Staff Report

To: Coalville City Planning Commission
From: Don Sargent, Community Development Director
Date of Meeting: June 17, 2024
Re: Red Hills Ranch MPD Phase 1 Final Plat and Construction Drawings
Action: Public Hearing and Possible Recommendation

Red Hills Ranch MPD Phase 1 Final Subdivision Plat and Construction Drawings

ATTACHMENT D

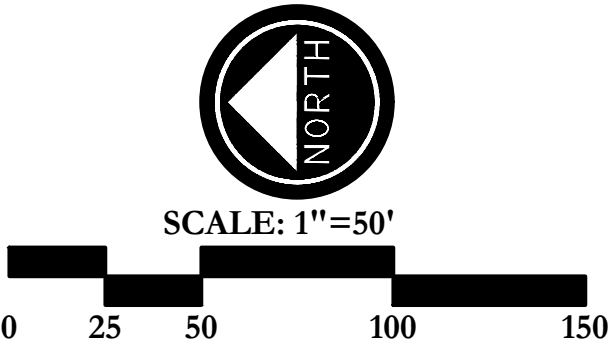
a. Open space plan calculations for Phase 1 the development verifying dedicated open space as approved with the overall MPD.

d. Park Area Plan calculations to verify required park area of 871 square feet of park space per unit of the approved MPD.

1. a. *See Sheet O-8 of the Improvement Plans for a tabulation of open space provided with each phase. This table will be updated with each new phase.*

Total open space required for MPD is 36.8 acres. Phase 1 proposed is 0.39 acre.

- d. *Park area is short of the 871 sf per unit requirement and will be with Phase 1 brought* current or exceed with a future phase. Applicant proposing 0.39 acre of landscaped park space for phase 1. Total required for 31 lots is 0.62 acres.
